Access Compliance Report

Public Rights-of-Way

(Curb Ramps)

Intersection ID: 29348	Main Street: MISTY_LN	Cross Street: ELIZABETH_RD	Location:	N
ADA ID: E64DA2BC96B7	Ramp Type: BlendTrans1	Initial Pass/Fail: Fail	Overall Compliance: No	Severity Score: 10
Codes/Mitigation Info/Possible Solution		Field Measurements/Component Compliance

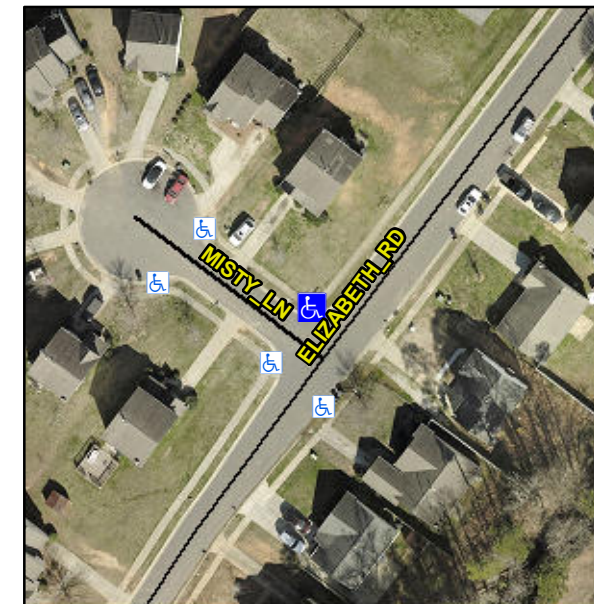
Not Found, R304.5.1, R304.5.3

Compliance	Description	Data	Compliance	Description	Data
N/A	Ramp Length (in)	48.0	Yes	BlendTrans Slope (%)	3.0
No	Ramp Width (in)	47.5	No	BlendTrans XSlope (%)	4.5
N/A	Flare Type LT	N/A	N/A	Flare Type RT	N/A
N/A	Flare Slope LT (%)	N/A	N/A	Flare Slope RT (%)	N/A
N/A	Flare Traversable LT?	N/A	N/A	Flare Traversable RT?	N/A
N/A	Landing Length (in)	N/A	N/A	DWS Provided?	N/A
N/A	Landing Width (in)	N/A	N/A	DWS Contrast?	N/A
N/A	Landing Slope (%)	N/A	N/A	DWS Length (in)	N/A
N/A	Landing X Slope (%)	N/A	N/A	DWS Full Width?	N/A
N/A	Landing Curb? (Y/N)	N/A	N/A	DWS Offset (in)	N/A
N/A	Shared Landing?	N/A			
N/A	Gutter Ponding?	N/A	N/A	Gutter Slope (%)	N/A
N/A	Gutter Lip Ht (in)	N/A	N/A	Gutter X Slope (%)	N/A
N/A	Painted X Walk1?	No	N/A	Painted X Walk2?	No
	X Walk 1 Direction	To SW		X Walk 2 Direction	To SE
	X Walk 1 Width (in)	N/A		X Walk 2 Width (in)	N/A
	X Walk 1 Slope (%)	0.8		X Walk 2 Slope (%)	5.3
	X Walk 1 X Slope (%)	4.5		X Walk 2 X Slope (%)	0.6

N/A	Ramp inside XWalk1?	N/A	N/A	Ramp inside XWalk2?	N/A
	Road Slope (%)	3.2		Clear Space?	N/A
	Road X Slope (%)	3.8	N/A	Clear Space to XWalk (in)	N/A
N/A	Any Obstructions?	N/A	N/A	Storm Grate/Utility Hazard?	N/A
	Obstruction Type			Storm Grate/Utility Type	
		N/A			N/A
			Yes	Surface Condition? (G/P)	Good
			No	Curb Slope (%)	16.2

Remove & Replace Curb Ramp With Two New Directional Ramps or Equivalent.
